CITY OF ALBUQUERQUE

**RE: 4515 Perdrocelli Court NW
Grading and Drainage Plan
Engineer's Stamp Date: 12/23/22
Hydrology File: F13D007**

DRAINAGE AND TRANSPORTATION INFORMATION SHEET (REV 6/2018)

Project Title: 4515 PEDRONCELLI NW **Building Permit #:** _____ **Hydrology File #:** _____

ENGINEER'S SEAL	LOT 14 PEDRONCELLI ADDITION 4515 PEDRONCELLI COURT	DRAWN BY DEM
DAVID SOULE NEW MEXICO REGISTERED PROFESSIONAL ENGINEER 14522	GRADING AND DRAINAGE PLAN	DATE 12-21-22
12/23/22	Rio Grande Engineering	Lot 14 Pedroncelli Addition DWG
DAVID SOULE P.E. #14522		SHEET # C1
		JOB #

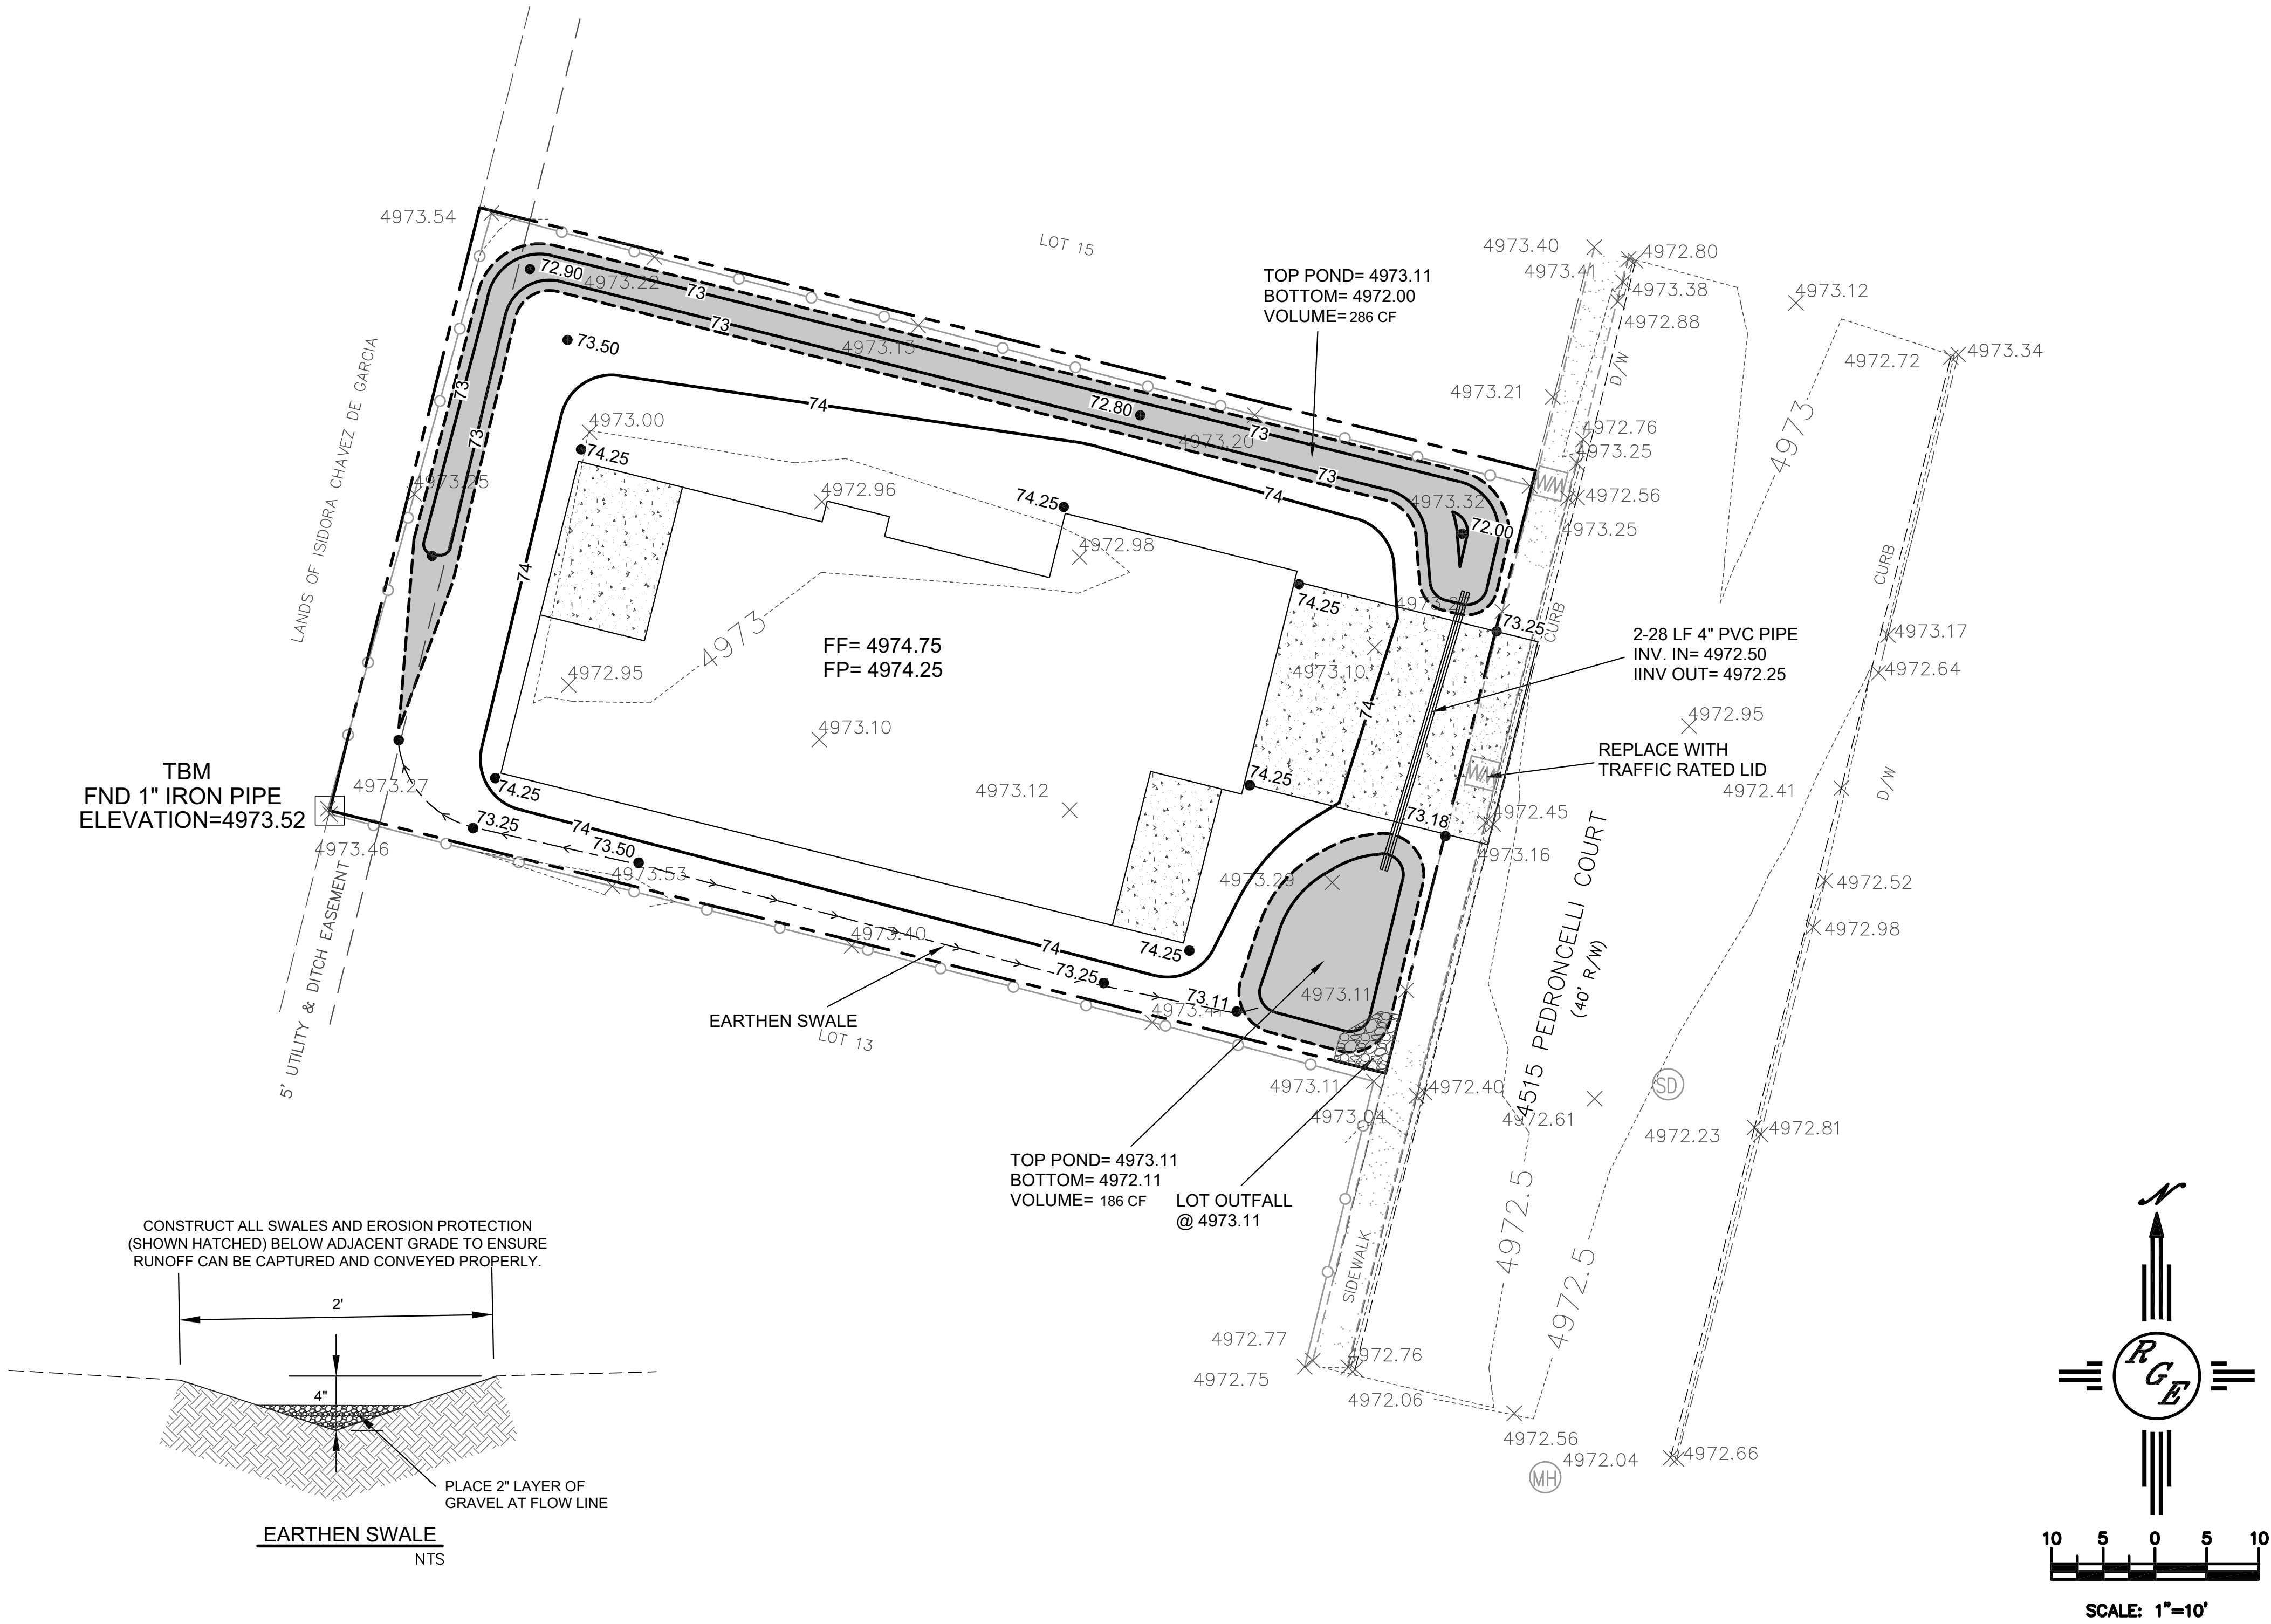
Based upon the information provided in your submittal received 12/27/2022, the Grading and Drainage Plan is approved for Building Permit and Grading Permit. Since this project is relatively flat and appears to have already been graded, a pad certification is not needed for this project. Please attach a copy of this approved plan in the construction sets for Building Permit processing along with a copy of this letter.

1. Engineer's Certification, per the DPM Part 6-14 (F): Engineer's Certification Checklist For Non-Subdivision is required.
